Paul Avenue Drainage Outfall Improvements

Forwarded herewith for execution is Change Order No. 1 for subject project.

Change Order No.	One (1)		Date January 31, 2014	
Description of Project	Paul Avenue Draiange Outfall Im	provements		
Name of Contractor	Besch & Smtih Civil Group, Inc.			
Contractor's Address	345 Cumberland Industrial Court	, St. Augustine, FL	. 32095	
Contract No. 9889		,		
Account No. See atta	ched	Original Contract	\$ 529,865.68 5	29802.68 W
+ Previous Change Orders *See attached appendix	for additional listings. TOTAL REVISED C		\$ 535,331.7 6 535 268	3.76 W
Bid Number CP-0006	Revised Construction Original Contrac Revised Contrac	Completion Date at Expiration Date at Expiration Date	February 3, 2014 April 2, 2014 June 3, 2014 July 31, 2014	
the CONTRACTOR sha	ral Conditions of above-referenced all make the following changes, ed. Add 58 non compensable calen	additions or delet	tions to the Work specified in	n the plans and
Justification: See attached	l.			
The Issuing Authority has necessary and all costs are	s looked over cost and pricing data e reasonable.	for this change or	rder and has determined that this	s change order is

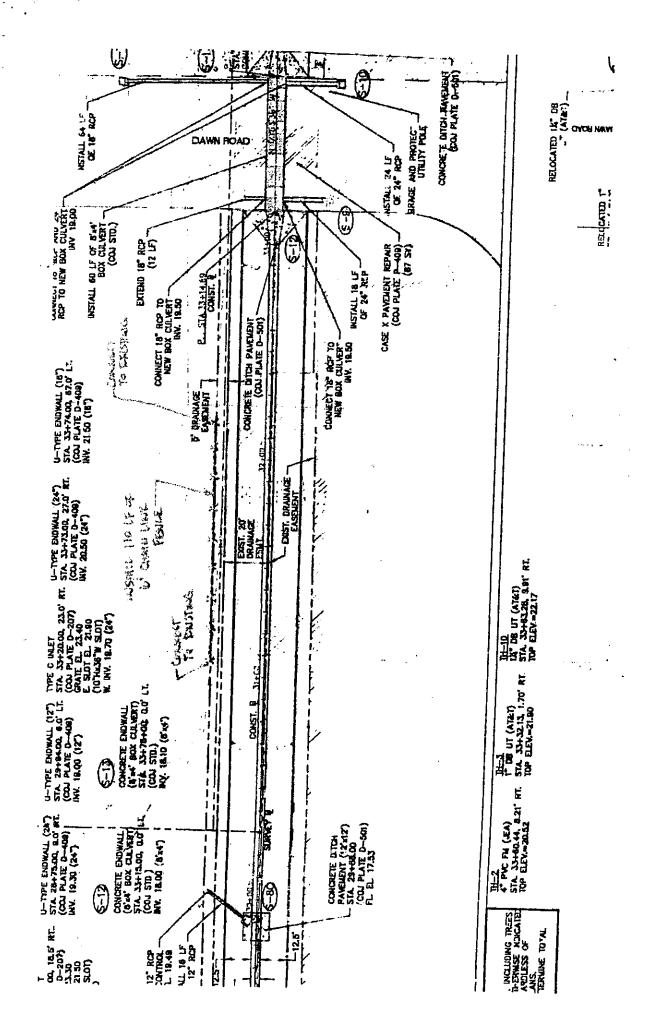
PROJECT: Paul Avenue Drainage Outfall	DATE: November 1, 2013				
Improvements	RFI #	5			
CONTRACTOR: Besch & Smith Civil Group Inc.	SPEC REF:	31.18			
CONTRACT/P.O. #:7525-08	DWG REF:	Plan Sheet 5			
RFI DESCRIPTION: Fence located south of Da	wn Ave, STA 3	31+20 to 32+35 is shown to be			
Removed. Fence is not shown to be replaced. Please ac	ivise if this fend	e is to be replaced, in like			
Kind, after removal of existing. if so, please show location	n of replacemen	nt fence.			
;					
SUBMITTED BY: Evan Lawrence					
Contractor's Representative					
REQUEST REPLY BY: 11-5-2013

REPLY: Submit for approval a detailed, itemized change order	request (based	upon the contract pay items) for			
the following additional work: Install new 6' Chain Link Fence (eq	ual or greater in	quality than the fence to be			
removed, including the 3 barb-wire strands at the top of the fence) along the prope	osed easement line located			
approximately 5 feet west of the existing fence line; see the attac	hed mark-up ske	tch. Connect the new fence to			
the existing fence at the north and south ends, installing the new	fence before rem	noving the existing fence, in order			
to maintain security of the adjacent private property. Commences	ment of the abov	e-described work may not			
commence until approval of the detailed change order.
